Subject: City of North Pole – West of Old Richardson Highway Stormwater Drainage Study

Subject: City of North Pole – West of Old Richardson Highway Stormwater Drainage Study,
Response to Department of Environmental Conservation's comments

Subject: City of North Pole – City-Wide Drainage Integrity Overview

Image 1: Proposed culvert under Kevins Way/Snowman Lane curve and bioswale in the right-of-way to the west of Snowman Lane

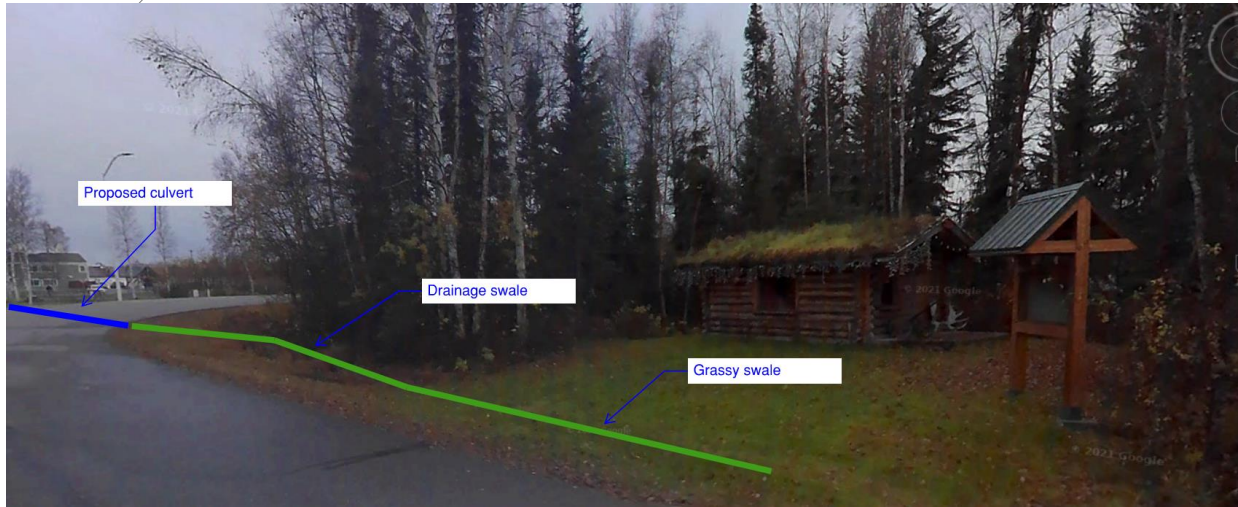
PROBLEM (12) PONDING IN THE SPRING CAN EXCEED LIMITS OF DETENTION POND BASIN. PONDING ON ROAD.**DEC'S RECOMMENDATIONS**

- / DEC's recommendation would be to install a large bioretention swale (rain garden), which would provide treatment of stormwater to remove coarse to medium sediments, while the bioretention system would remove finer particulates and associated contaminants. Stormwater runoff flows into the swale and slowly percolates through the soil (which acts as a filter) and into the groundwater; some of the water is also taken up by the plants.

- » With the school in near proximity this location would be excellent as an educational opportunity/outdoor classroom experience.
- / Pumping the ponding area directly into Thirty-mile Slough/Beaver Springs is not recommended without some type of pretreatment due to the likelihood of pathogen bacteria in that stormwater from the dog park.

- / We recommend improving the infiltration in the retention basin by excavating to remove clogged soils. Reconstruction will include the addition of 18 inches of bioretention media to the pond bottom to create a natural filter that will resist future clogging and wetland plugs that will increase infiltration and encourage pollutant uptake. A riser pipe that is perforated and encased with gravel beneath the filter media will serve as a pumping location to both minimize soil and organics uptake to the pump, and to provide for initial pretreatment of the ponded water prior to discharge from the pond. The dimensions of the improved retention basin will be 35 feet by 50 feet with 4:1 side slopes.

- / In the springtime, even with the improvements, the frozen soil will continue to cause the retention basin to overflow and require pumping. We propose to make use of the considerable City of North Pole right-of-way to the west of Snowman Lane to construct a bioswale, which will include the construction of a culvert under Kevin's Way. This 30 foot culvert will allow the city to better control ponding in the outdoor exercise yard and will allow the city to pump from the retention basin to

within the upstream end of the culvert. The 90-foot bioswale will have structures to encourage ponding and infiltration, such as check dams. This will provide an opportunity for sediment retention to encourage infiltration and treatment of the runoff by the bioswale before it reaches the slough. The bioswale will discharge to an existing lawn ditch for about 35 feet before flowing about 30 feet overland down the side of the slough to water.
